INNOVATIVE TECHNOLOGY EVALUATION (ITE)  
OF MCCORMICK AND BAXTER  
PORTLAND, OREGON

FEBRUARY 28, 2006

FOR  
OREGON DEPARTMENT OF ENVIRONMENTAL  
QUALITY

**DEQ Response to  
NOAA Comments on the Draft Innovative Technology Evaluation  
of McCormick & Baxter**

Figure 5

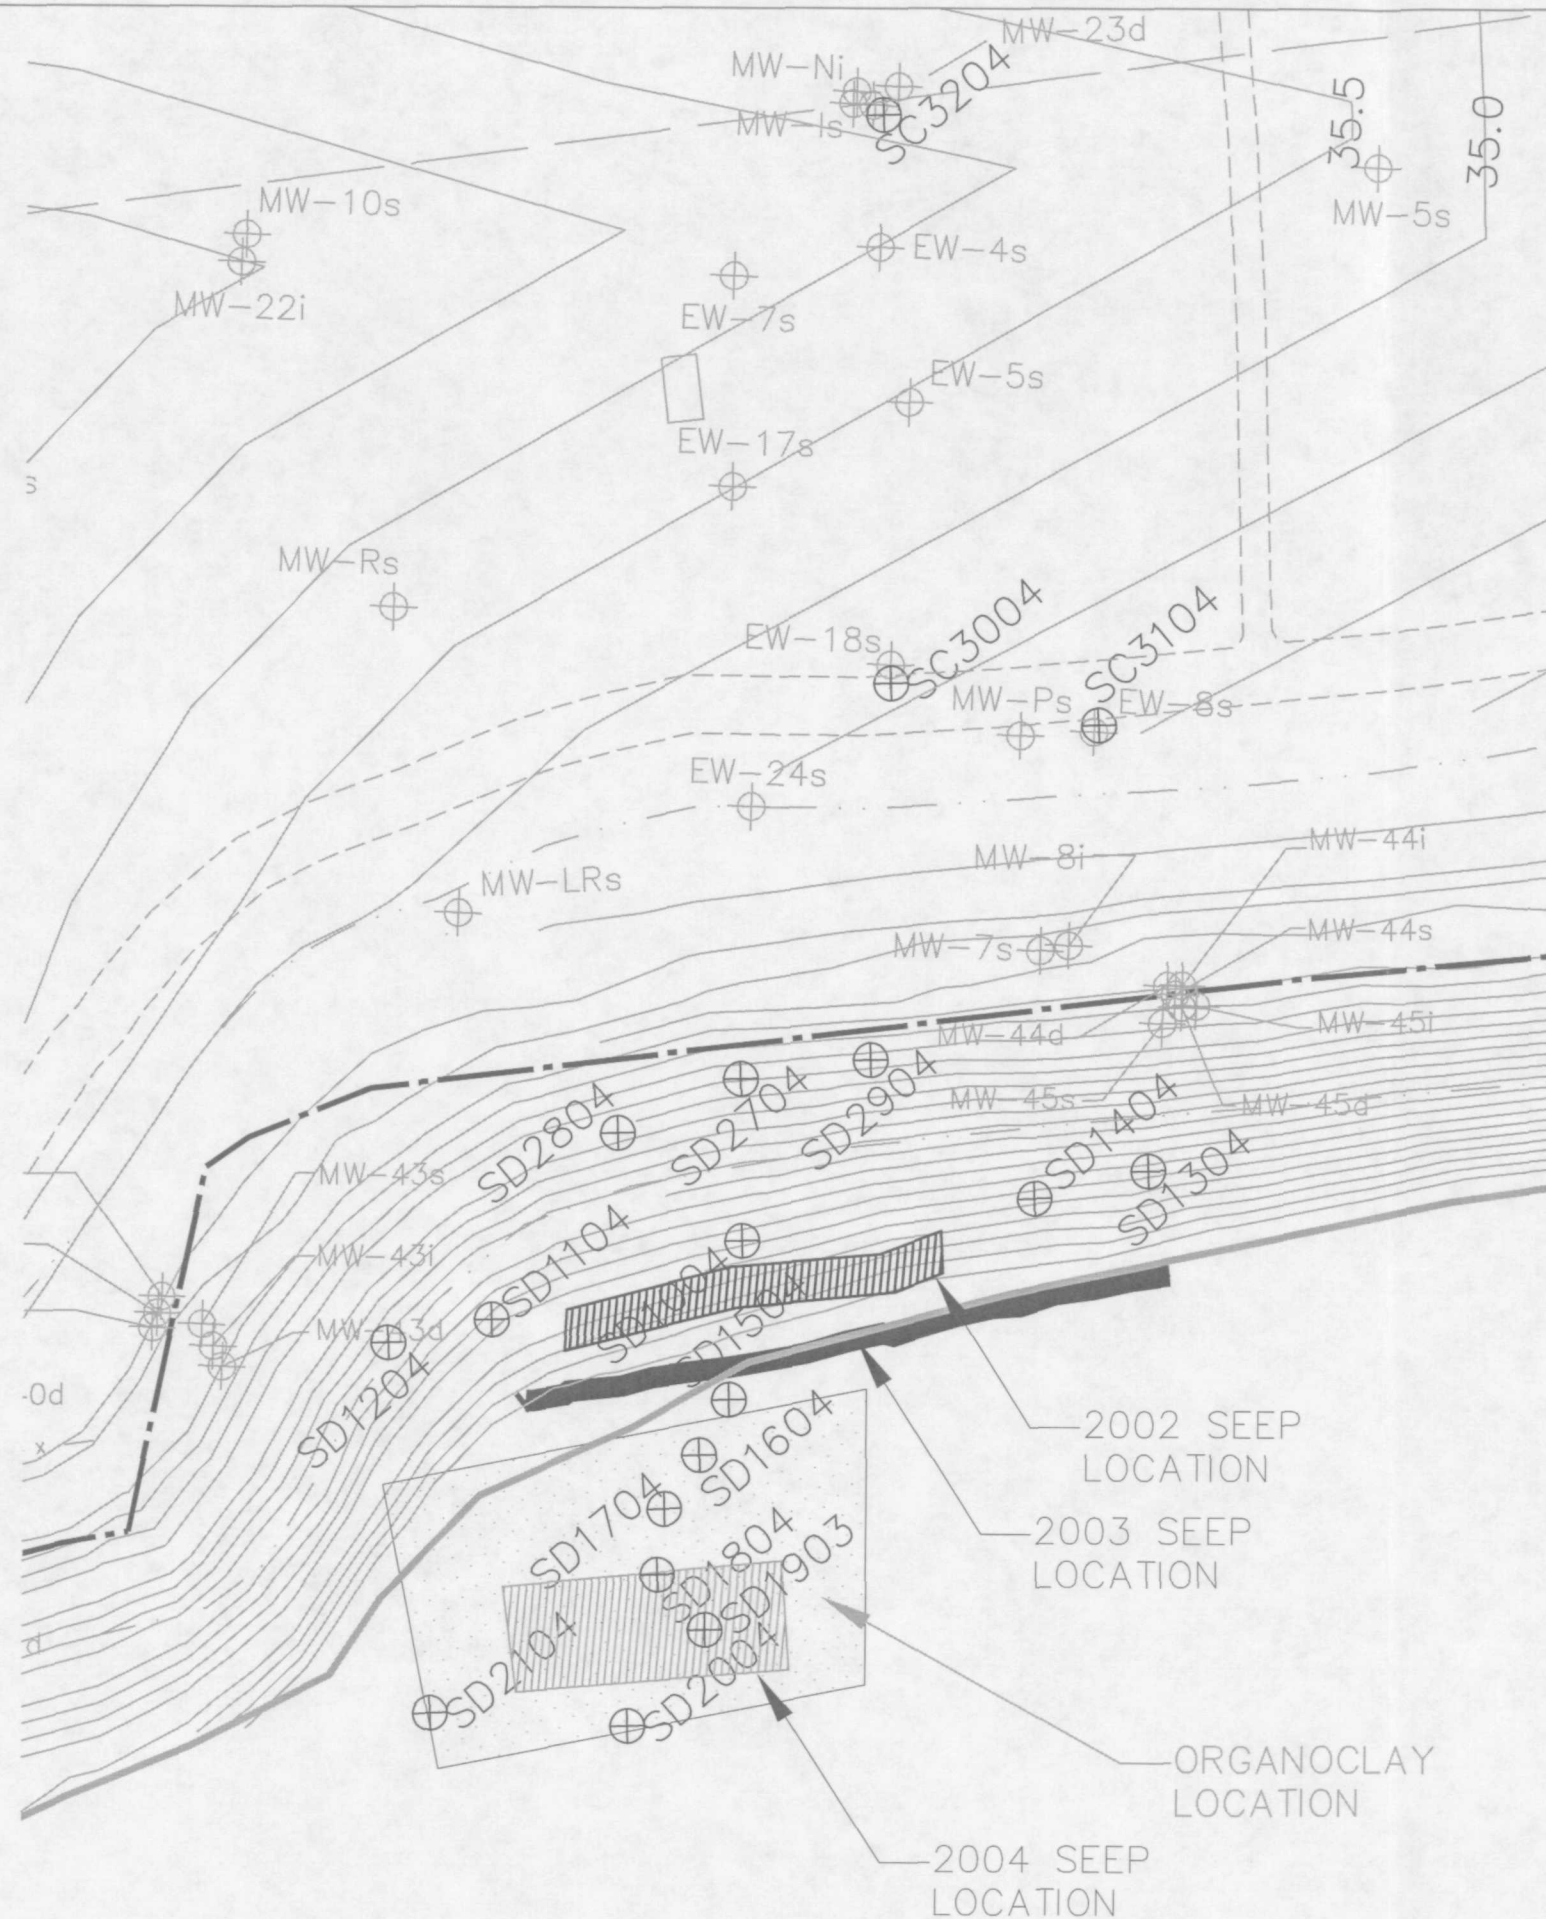
**Pg. 7, Sec. 3.1 Former Waste Disposal Area and Figure 5:** *"The subsurface between the barrier wall and Willamette Cove is underlain by alluvial sands (Figure 5) with a gravel zone coincidental with the water table. The gravel zone appears to provide a preferential pathway for groundwater and LNAPL migration to Willamette Cove. The lateral extent of ?NAPL in this area corresponds to an area approximately 250 ft square (Figure 5)."* There are both LNAPL and DNAPL in this area. Only the lateral extent of the LNAPL has been established, and the statement should be specific to LNAPL.

**Pg. 7, Sec. 3.1 Former Waste Disposal Area and Figure 5:** Figure 5 inappropriately assumes the DNAPL found in MW-20i does not extend downward or river-ward from the wellscreen. The extent of DNAPL around this wellscreen is unknown, but substantial quantities of DNAPL have been removed, and continue to be removed, suggesting sufficient upgradient DNAPL to maintain mobility (approximately 6 gal of DNAPL was recovered from MW-20i in both Sept and Oct 2005). The figure should indicate broader extent of DNAPL surrounding this wellscreen, with unknown delineation of the edges, especially toward the river. Since DNAPL is being recovered from MW-Gs and MW-Ds, also; why not use their well screen depths and boring logs to add additional information to this figure?

Revision made to text. See Section 3.1, 2<sup>nd</sup> paragraph. L was added to the NAPL as DEQ is referring to LNAPL.

Figure 5 was revised to add the uncertainty in DNAPL extent.

**Figure 8**

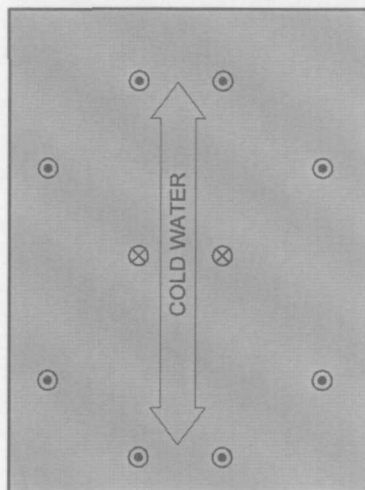
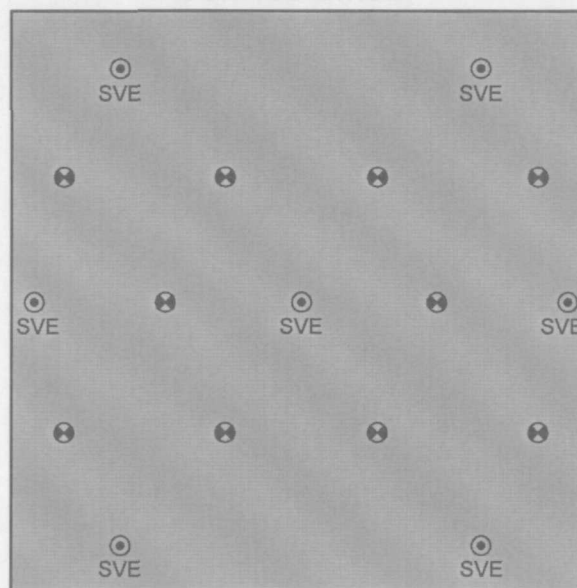
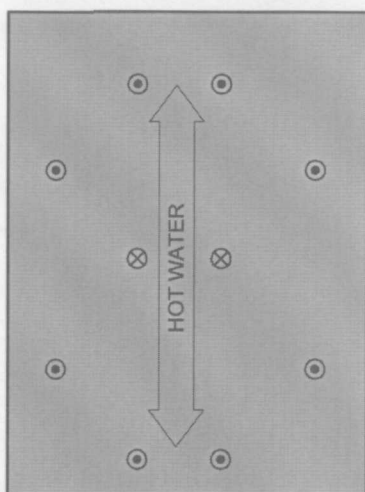
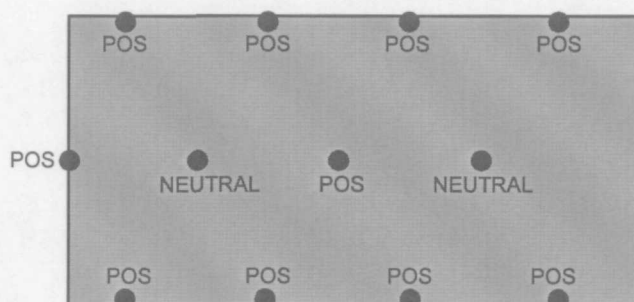
**Pg. 13, Sec. 5.3, Innovative Technology 1, Cold Water Flooding:** *"Figure 8 illustrates the conceptual well field in plan view."* Figure 8 is a schematic for each of the technologies but it does not locate the unit cells on the McCormick and Baxter site. These systems would need to be placed adjacent to a large volume river that experiences tidal and seasonal fluctuations in water elevation. How would hydraulic control be established during IT treatment, and what is the estimated cost?

See response to Comment 10.
